RECOMMENDED SERVICE BULLETIN

RSB 62-010/1

Replacement of the turbocharger V-clamps.
ATA-Code: 81-00

WI-RSB 62-010

Figure 9

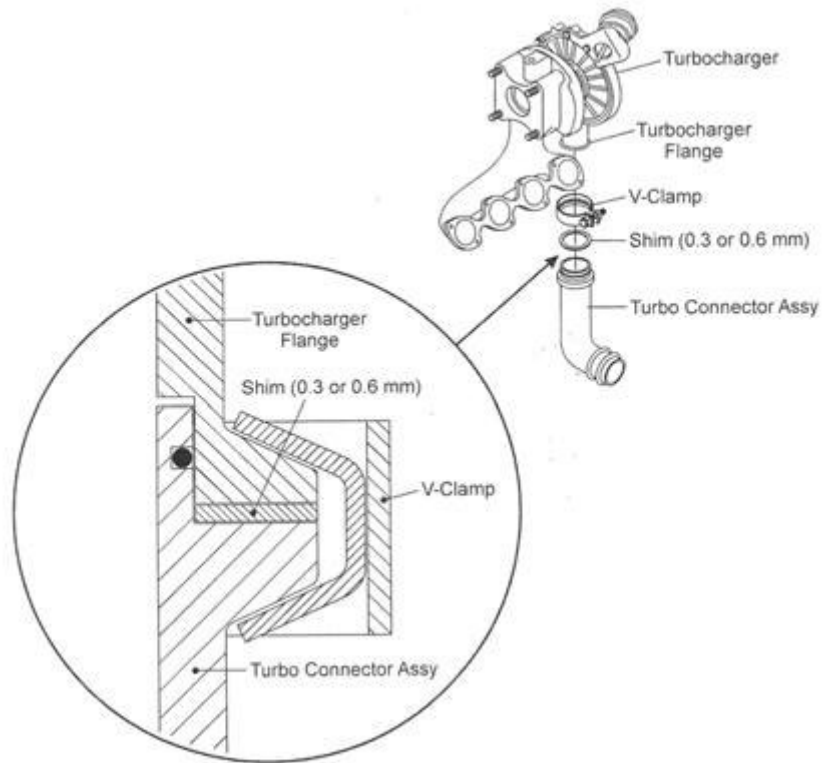
- Make sure that the distance between V-flanges on the lock is between 6 and 10 mm (refer to Figure 8). If necessary, insert turbo connector shims to obtain the required distance (refer to Figure 9).

Figure 8

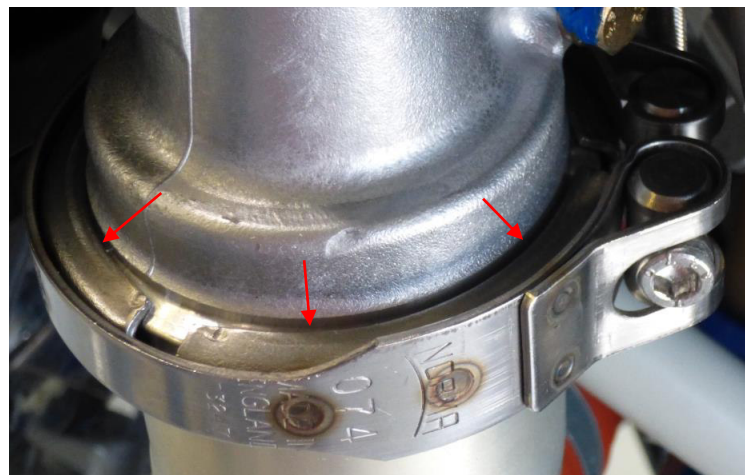
- Make sure the circumferential gap to the turbocharger is equal (if not, use rubber mallet to tap V-clamp into position). If tapping with a rubber mallet was required, retighten to 5.5 ± 0.5 Nm (4.0 ± 0.4 lbf.ft). Refer to Figure 8.
